# Access Compliance Report

## Public Rights-of-Way

### (Curb Ramps)

Intersection ID: N/A	Main Street: NINA_DR	Cross Street: W_T_HARRIS_BV	Location: NW
ADA ID: 2D0DDEE6D565	Ramp Type: Para	Initial Pass/Fail: Fail	Overall Compliance: No
Severity Score: 13.75			
Codes/Mitigation Info/Possible Solution		Field Measurements/Component Compliance

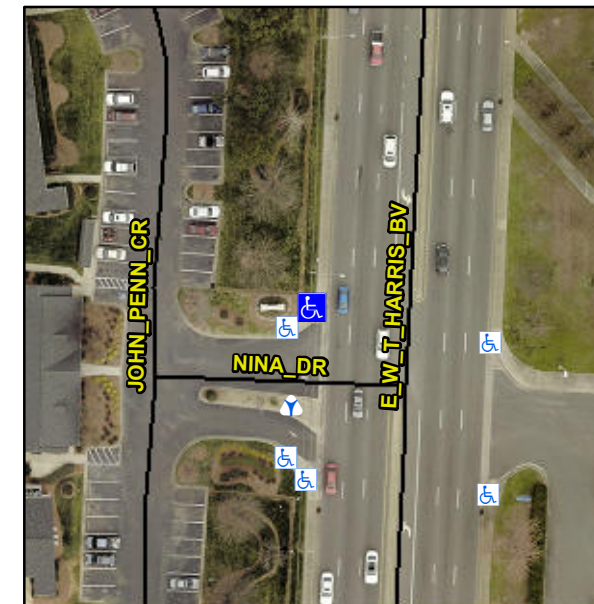
**MEDIAN ACROSS W T HARRIS BV**

**R304.3.2, R304.5.3**

Compliance	Description	Data	Compliance	Description	Data
N/A	Ramp Length LT (in)	63.0	N/A	Ramp Length RT (in)	62.5
Yes	Ramp Width LT (in)	59.0	Yes	Ramp Width RT (in)	60.0
Yes	Ramp Slope LT (%)	7.4	No	Ramp Slope RT (%)	9.8
Yes	Ramp XSlope LT (%)	0.5	No	Ramp XSlope RT (%)	2.6
N/A	Landing Length (in)	N/A	N/A	DWS Provided?	N/A
N/A	Landing Width (in)	N/A	N/A	DWS Contrast?	N/A
N/A	Landing Slope (%)	N/A	N/A	DWS Length (in)	N/A
N/A	Landing X Slope (%)	N/A	N/A	DWS Full Width?	N/A
N/A	Landing Curb? (Y/N)	N/A	N/A	DWS Offset (in)	N/A
N/A	Shared Landing?	N/A			
N/A	Gutter Ponding?	N/A	N/A	Gutter Slope (%)	N/A
N/A	Gutter Lip Ht (in)	N/A	N/A	Gutter X Slope (%)	N/A
N/A	Painted X Walk1?	No	N/A	Painted X Walk2?	N/A
	X Walk 1 Direction	To E		X Walk 2 Direction	N/A
N/A	X Walk 1 Width (in)	N/A	N/A	X Walk 2 Width (in)	N/A
	X Walk 1 Slope (%)	0.6		X Walk 2 Slope (%)	N/A
	X Walk 1 X Slope (%)	1.0		X Walk 2 X Slope (%)	N/A
N/A	Ramp inside XWalk1?	N/A	N/A	Ramp inside XWalk2?	N/A

**Remove & Replace Entire Ramp.**
